Re: Florida Power & Light Company
Proposed Turkey Point Units 6 and 7
Docket Nos. 52-040 and 52-041
Response to NRC Environmental Audit Data and Information Need Items
AQ-4, H-13, H-23, H-31, H-34, H-35, H-38, H-40, NR-6

L-2011-174
10 CFR 52.3

Attachment 1: FPL Response to NRC Item H-13 (ER 4.2)

Attachment 2: FPL Response to NRC Item H-23, H-31, H-34, H-38, H-40, NR-6
(ER 5.2)

Figure 5.2-1 Radial Collector Well Drawdown in Model Layer 1 (Muck Layer)

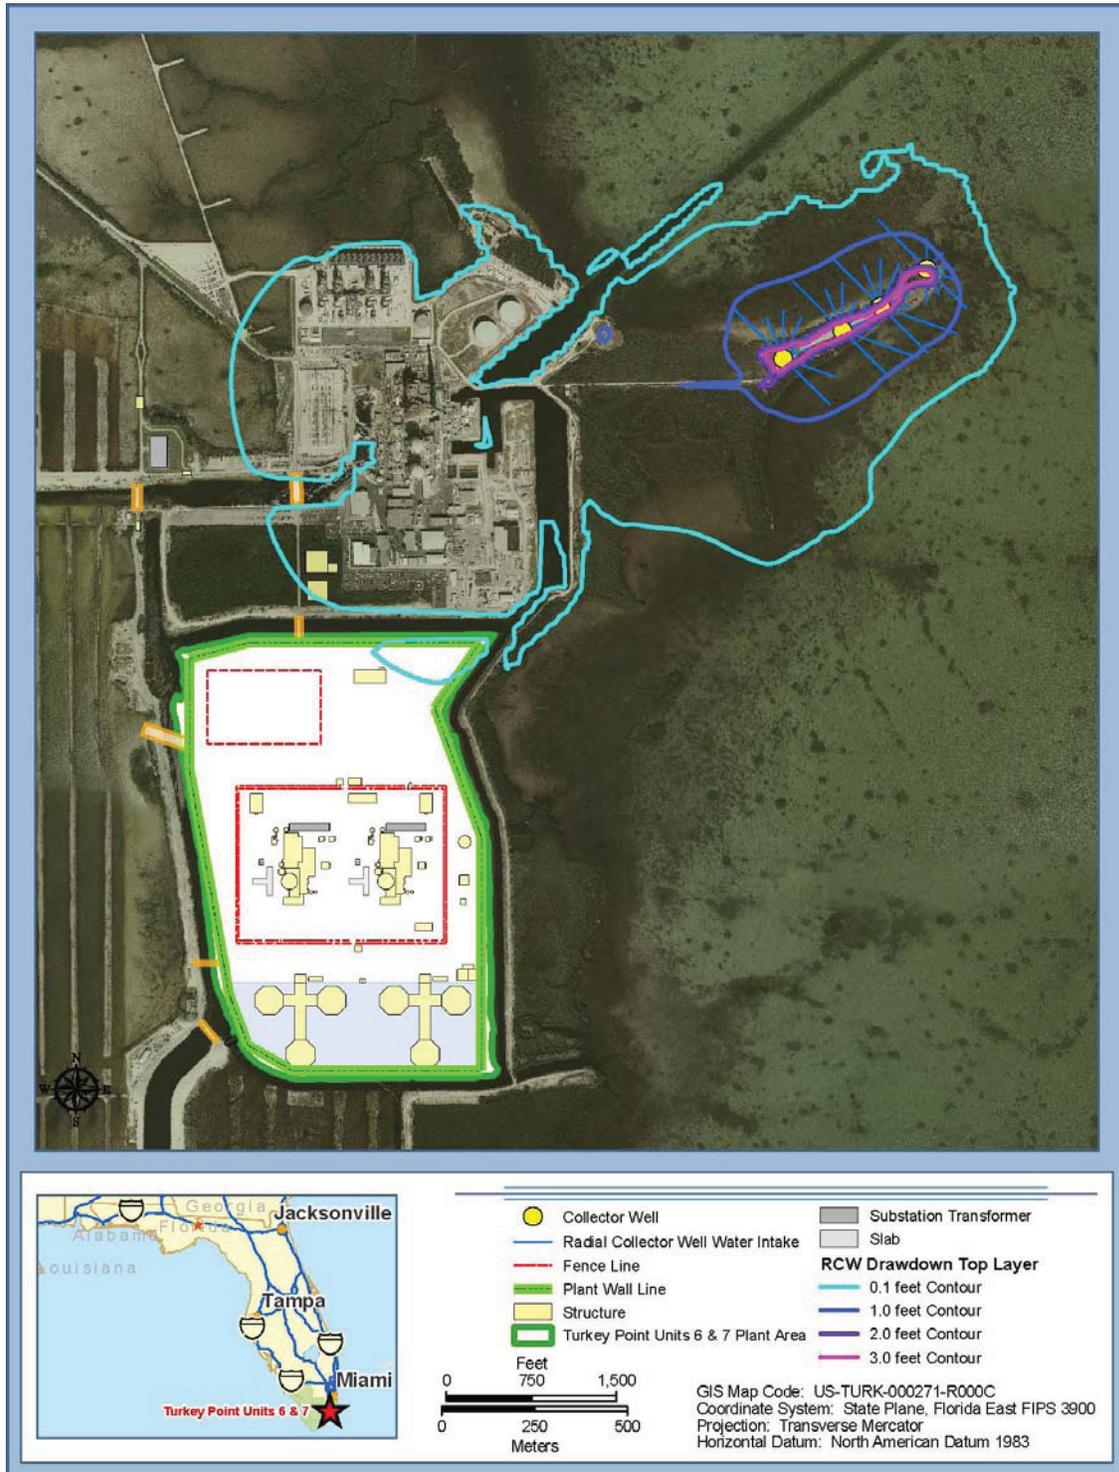
Have available the subject matter expert responsible for the ER analysis of the groundwater model and have available for review the GIS information, including the original GIS layer and Digital Elevation Map (DEM data used to generate Figure 5.2-1. (H-34)

peninsula would range from 1 to 3 feet. Drawdown west of Turkey Point would be generally confined to the shoreline adjacent to Units 1 through 5 and would be approximately 0.1 feet (see Figure 5.2-1).

The model indicates that the uplands could be dewatered on the Turkey Point peninsula during steady state conditions; however this would be confined to areas immediately around the radial collector wells. Drawdown in the muck layer on the eastern shoreline, based on the results of the groundwater model, is not anticipated (see Figure 5.2-1).

ER Figure 5.2-1 will be revised and a new Figure 5.2-2 will be added as shown on the next two pages to reflect the item response.

Figure 5.2-2 Radial Collector Well Drawdown in Model Layer 4 (Upper Higher Flow Zone)

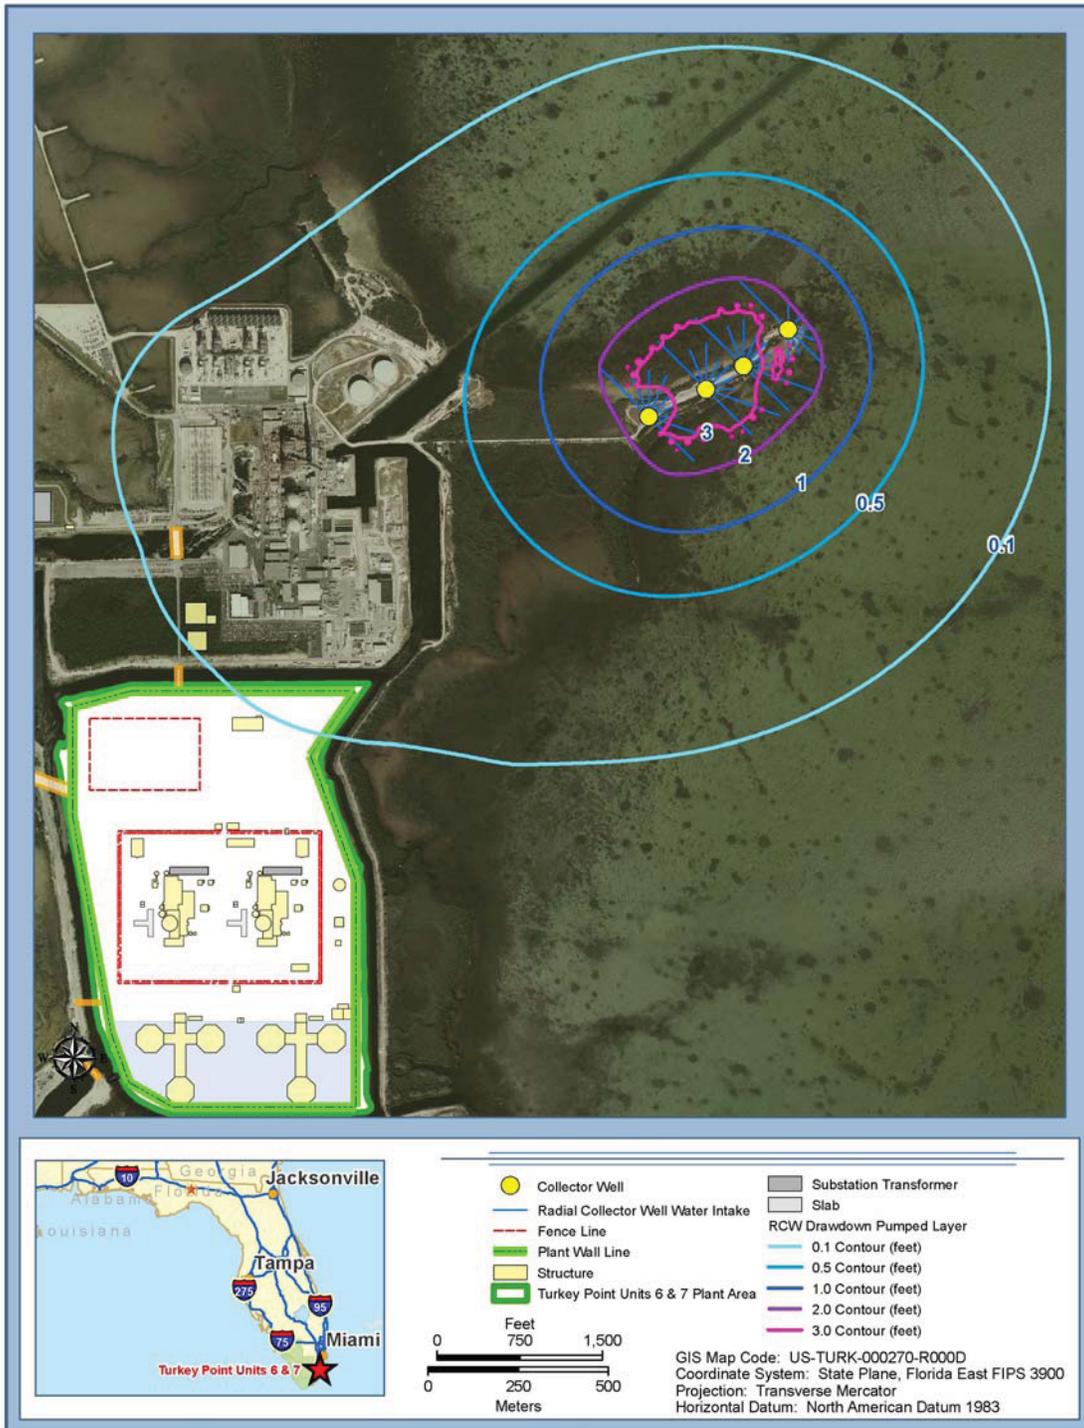
The cone of depression in Model Layer 1 (onshore – muck; offshore – rock/sand) ranged from 3 to 0.1 feet and was generally confined to the area local to the radial collector wells (areal extent of 211 acres based on the 0.1 foot drawdown contour in Biscayne Bay) and the Units 1 through 5 plant area, as depicted in Figure 5.2-1 (refer to ‘Associated COLA Revisions’ for figure). The drawdown in Model Layer 4 (Upper Higher Flow Zone) ranged from 3 to 0.1 feet and was also generally confined to the area local to the radial collector wells (areal extent of 729 acres based on the 0.1 foot drawdown contour in Biscayne Bay), as depicted in Figure 5.2-2 (refer to ‘Associated COLA Revisions’ for figure).

As previously discussed, groundwater modeling was performed to simulate the steady-state conditions resulting from operation of the radial collector wells. The cone of depression in Model Layer 1 (onshore – muck; offshore – rock/sand) ranged from 3 to 0.1 feet and was generally confined to the area local to the radial collector wells (areal extent of 211 acres based on the 0.1 foot drawdown contour in Biscayne Bay) and the Units 1 through 5 plant area, as depicted on Figure 5.2-1. The drawdown in Model Layer 4 (Upper Higher Flow Zone) ranged from 3 to 0.1 feet and was also generally confined to the area local to the radial collector wells (areal extent of 729 acres based on the 0.1 foot drawdown contour in Biscayne Bay), as depicted in Figure 5.2-2.
